# Access Compliance Report Public Rights-of-Way (Island Curb Cuts)

Main Street: O\_NEILL\_DR Cross Street: O\_NEILL\_DR Location: NW

ADA ID: CCRK211111131346 Curb Cut Type: MedianRefuge2 Initial Pass/Fail: Fail Overall Compliance: No Severity Score: 30

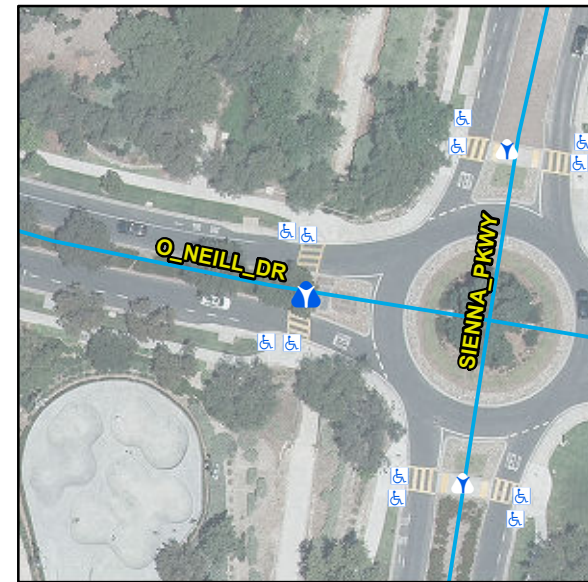
| Compliance | Description                | Data       | Compliance | Description              | Data |
|------------|----------------------------|------------|------------|--------------------------|------|
| No         | Refuge 2 Slope (%)         | 10.1       | N/A        | Gutter 2 Slope (%)       | N/A  |

Remove & Replace Entire Refuge.

R302.5, STD 1115
